General Information

When replacing a hood pivot on a Western Star 4900 vehicle, discard the old fasteners and replace them with the new fasteners listed in [Table 1](#) and [Table 2](#), using the procedure in this bulletin.

Fig. 3, Hood Pivot

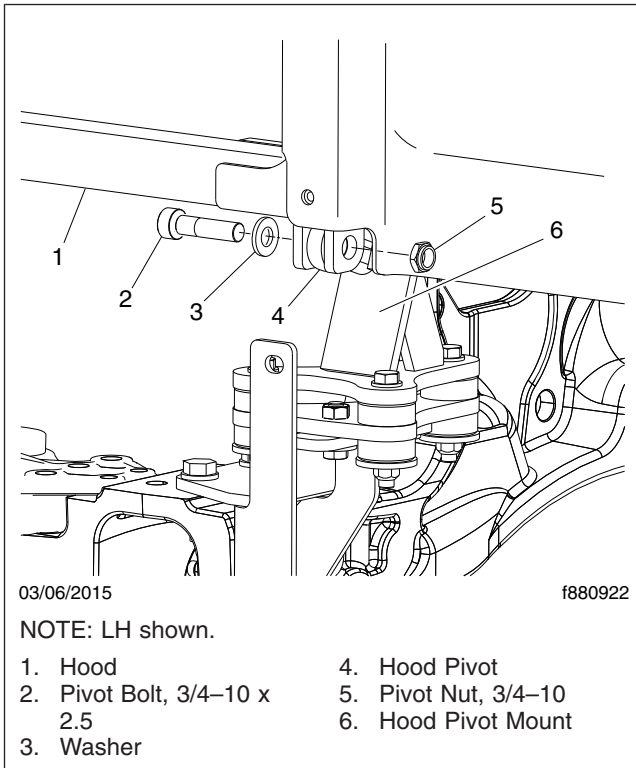
7. Remove the hood pivot nut, bolt, and washer. See [Fig. 3](#).
8. Carefully roll or slide the hood support and hood away from the vehicle.
9. Remove the hood pivot from the pivot mount. Discard the capscrew and washer. See [Fig. 4](#).

10. Using a new capscrew and lockwasher (see [Table 1](#)), install the hood pivot on the mount. Tighten the capscrew 170 to 180 lbf-ft (230 to 244 N·m). See [Fig. 4](#).
11. Supporting the hood, align the pivot bracket on the hood with the pivot.
12. Using new fasteners (see [Table 2](#)), insert the pivot bolt and washer, and secure with the nut. See [Fig. 3](#). Tighten the nut 260 lbf-ft (350 N·m).
13. Plug in the headlight harness connectors and use tie straps to fasten them securely to the hood.
14. Close the hood half-way and support it. Bolt the torsion springs and safety cables to the radiator bracket. Tighten the torsion spring and safety cables 16 lbf-ft (21 N·m).
15. Remove the hood support and close and latch the hood.
16. Check and adjust the hood alignment following the instructions in *Western Star Workshop Manual*, **Section 88.00, Subject 120**.

Parts for Hood Pivot Replacement, 4900 Models		
Part Number	Description	Qty.
23-14085-250	SCREW-CAP, HEXSOCH, 3/4-10 x 2.5	2
23-09114-014	WASHER-HRDN, 0.81 x 1.13 x 0.177, ZN	2
23-13577-111	NUT-PTRQ 3/4-10NC GRC	2
